APPENDIX K2

2023 QIA Inspections and Baffinland's Responses

**Re: Baffinland Iron Mines Corporation's Mary River Project – Qikiqtani Inuit Association
June 2023 General Site Inspection Findings and Recommendations**

RE: QIA June 2023 General Site Inspection Findings and Recommendations - Response

WORK AREA LAYOUT PLAN VIEW

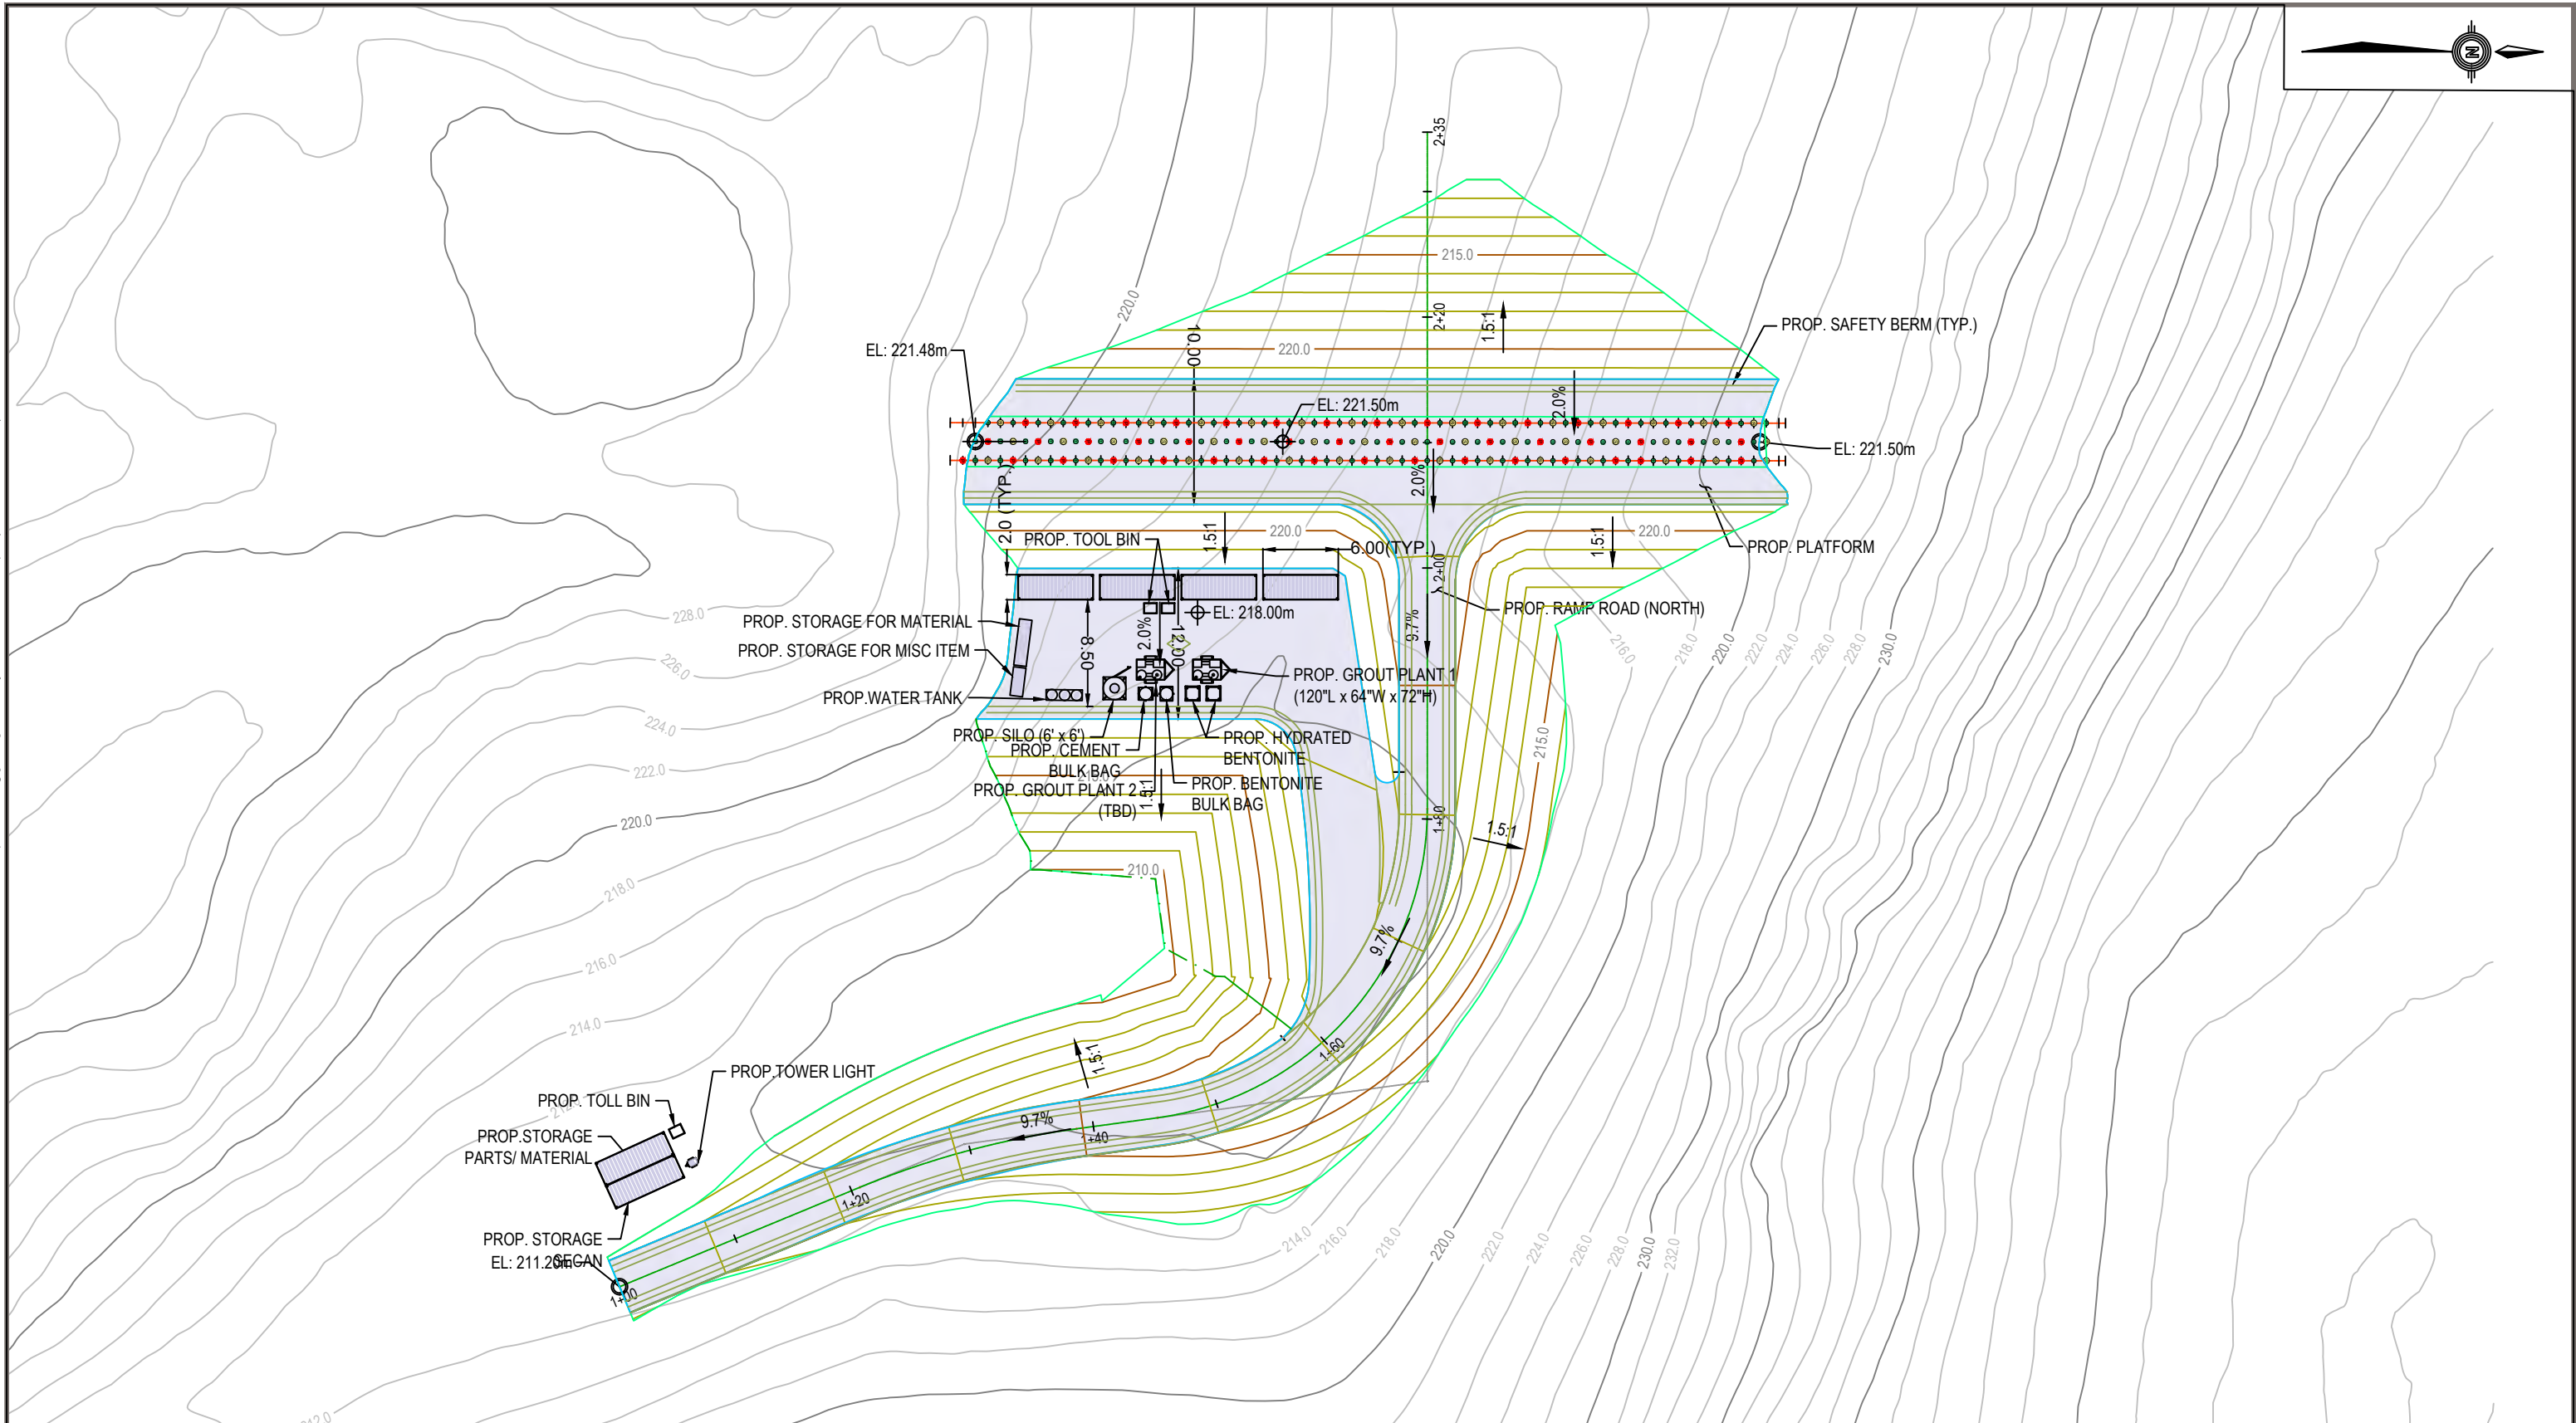
1. Revised alignment for the grout curtain: the grout curtain was shifted to the east by about 25 m to allow for the grout holes to be advanced through the existing geomembrane liner. This will accommodate a direct connection between the top of the grout curtain and the existing liner system for the pond.
2. Revised alignment of the temporary platform: the temporary platform was realigned to match the revised alignment of the grout curtain.
3. Temporary platform fill material: the central core material was changed to 19 mm minus crushed sand and gravel from 50 mm crushed sand and gravel to accommodate the change in drilling methodology, as recommended by Keller.
